## Meeting Agenda Historic Review Board

Tuesday, January 24, 2017

**FILE NO.:** HR 16-02: Historic Review Board review of construction of a new single family residence in the Canemah National Historic District.

**To:** Historic Review Board  
**From:** Trevor Martin, Christina Robertson-Gardiner, Oregon City Planning Division  
**Re:** HRB 15-01 New Construction Deck Review–HRB Concurrence

SITE PLAN

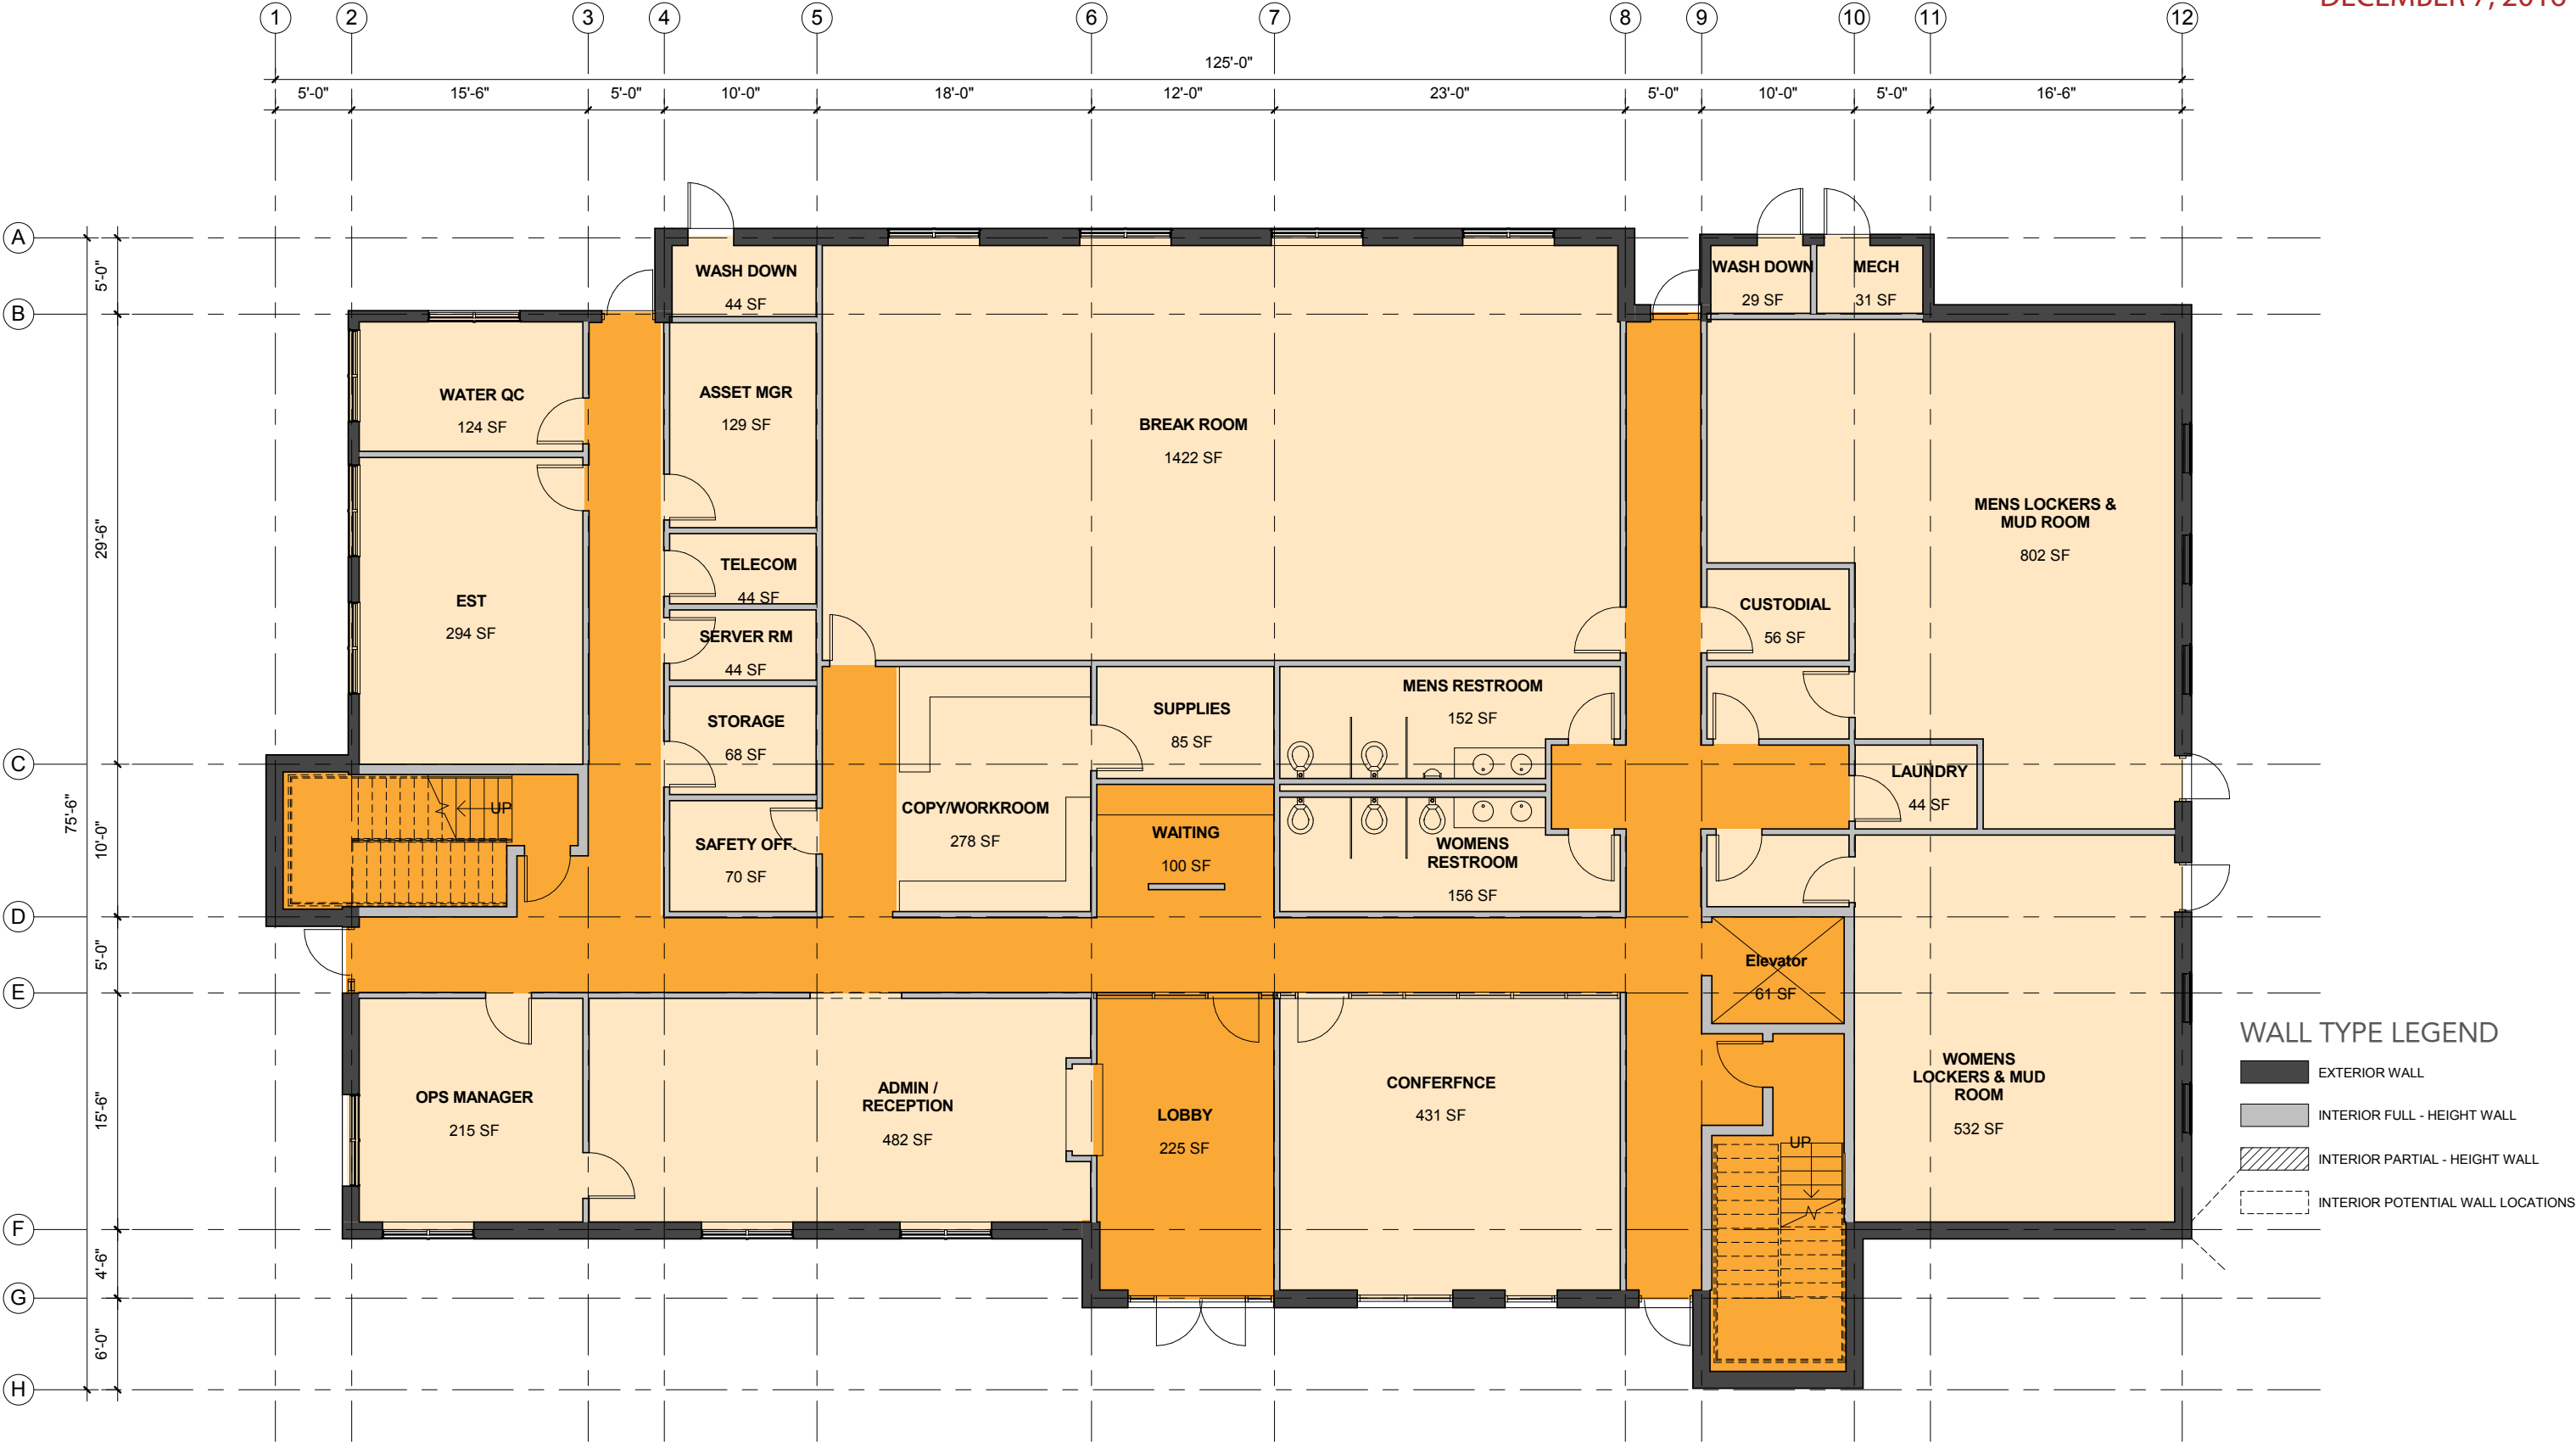
- Can we maintain the existing discharge outfall to 1<sup>st</sup> street located in the northeast corner of the site? If not, can we construct a storm line within the 1<sup>st</sup> street ROW to an existing conveyance system.
- If we can demonstrate the ability to achieve partial detention requirements, can a fee in lieu be applied for the remaining portion?
- Is there an existing regional detention facility in the projects contributing basin that can be modified?
- The underlining soils are believed to be bedrock. Can our existing conditions model account for this by applying a type D soil classification with proper documentation?

Due to OCPW facility needs and site constraints the proposed development will require multiple exceptions. Please, provide the anticipated required exceptions.

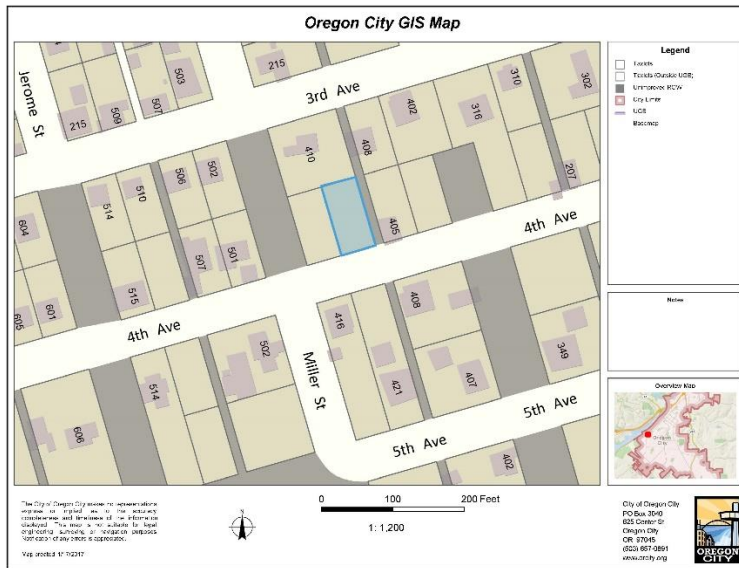
1. The applicant shall submit a revised plan without the massing of an enclosed breezeway in the proposed design.(P)
2. The applicant shall submit a landscaping plan with a vegetative buffer reducing the massing for the north and east side of the house.(P)

- a. Three to six additional minimum 1 ½ inch caliper trees that are a mix of native evergreen and deciduous with a minimum mature height of 35 feet planted to better buffer the new construction from the neighborhood and hide the massing of the building. Staff will review the final landscape plan at the time of Certificate of Occupancy to determine the minimum number of trees required to meet this condition.

**Revise the deck design to conform to HR 15-01 Conditions of Approval and be consistent with submitted railing details of the house.**

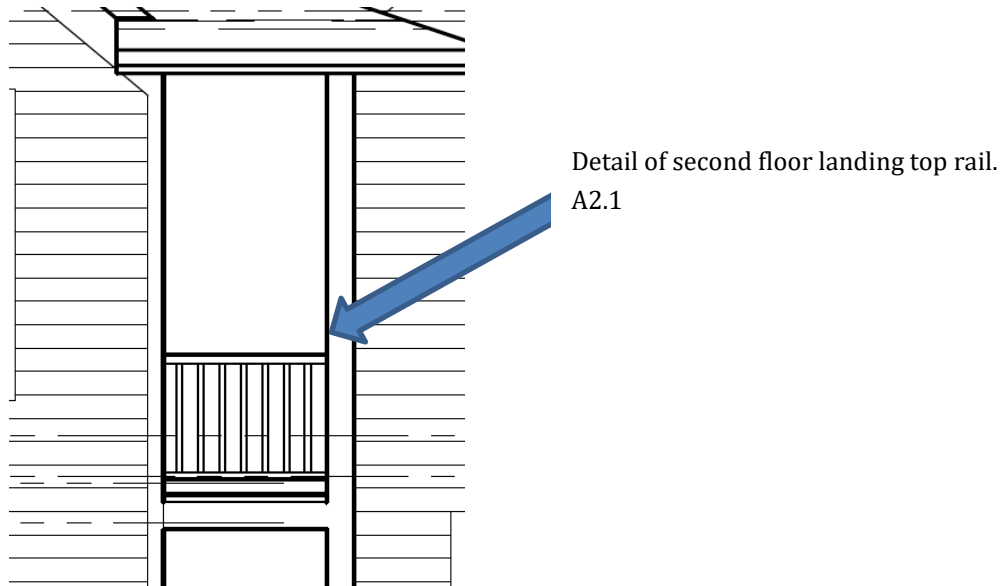
The applicant has constructed a painted wood deck that generally corresponds to the proposed patio and, while above grade, does not create a sustainably new element onsite. However, the applicant has failed to provide a design approach to cover the exposed pressure treated wood, as conditioned. This could be in the form of painted 1"x8" boards, lap siding, historically appropriate wood lattice, or a

As the deck was not originally submitted, staff will rely upon the railing design submitted for the second floor landing. This shows a top rail over flush vertical balusters. The deck, as built, does not meet this standard and needs to be revised to be consistent with the design found in Plan A2.1 of the applicant's submittal shown below.

With this approach, the applicant shall present to staff a proposal that can meet the Conditions of Approval and existing railing detail. Compliance with the conditions and railing detail will allow the new deck to be reviewed at a staff level and the applicant will be able to obtain the final Certificate of Occupancy. If staff is unable to find compliance with the adopted conditions- the applicant will be required to pursue Options 2 or 3 below.
